Intersection ID: 2453	Main Street: CLARKE_CREEK_PY	Cross Street: BROOKINGS_DR	Location:	SE
ADA ID: 855E76379D19	Ramp Type: PerpDiag	Initial Pass/Fail: Fail	Overall Compliance: No	Severity Score: 21.25

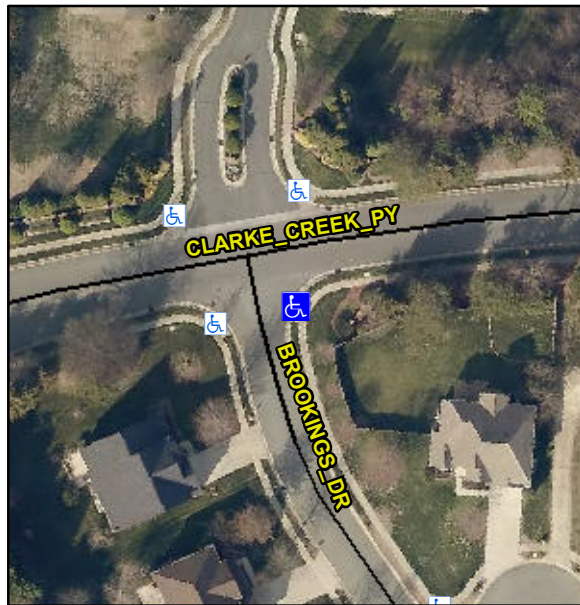
Not Found, R304.5.1, R304.5.3

Compliance	Description	Data	Compliance	Description	Data
N/A	Ramp Length (in)	50.0	Yes	Ramp Slope (%)	7.1
No	Ramp Width (in)	44.0	No	Ramp XSlope (%)	5.1
N/A	Flare Type LT	N/A	N/A	Flare Type RT	N/A
N/A	Flare Slope LT (%)	N/A	N/A	Flare Slope RT (%)	N/A
N/A	Flare Traversable LT?	N/A	N/A	Flare Traversable RT?	N/A
N/A	Landing Length (in)	N/A	N/A	DWS Provided?	N/A
N/A	Landing Width (in)	N/A	N/A	DWS Contrast?	N/A
N/A	Landing Slope (%)	N/A	N/A	DWS Length (in)	N/A
N/A	Landing X Slope (%)	N/A	N/A	DWS Full Width?	N/A
N/A	Landing Curb? (Y/N)	N/A	N/A	DWS Offset (in)	N/A
N/A	Shared Landing?	N/A			
N/A	Gutter Ponding?	N/A	N/A	Gutter Slope (%)	N/A
N/A	Gutter Lip Ht (in)	N/A	N/A	Gutter X Slope (%)	N/A
N/A	Painted X Walk1?	No	N/A	Painted X Walk2?	No
	X Walk 1 Direction	To NE		X Walk 2 Direction	To NW
N/A	X Walk 1 Width (in)	N/A	N/A	X Walk 2 Width (in)	N/A
	X Walk 1 Slope (%)	0.8		X Walk 2 Slope (%)	0.2
	X Walk 1 X Slope (%)	2.2		X Walk 2 X Slope (%)	2.4

Remove & Replace Curb Ramp With Two New Directional Ramps or Equivalent.
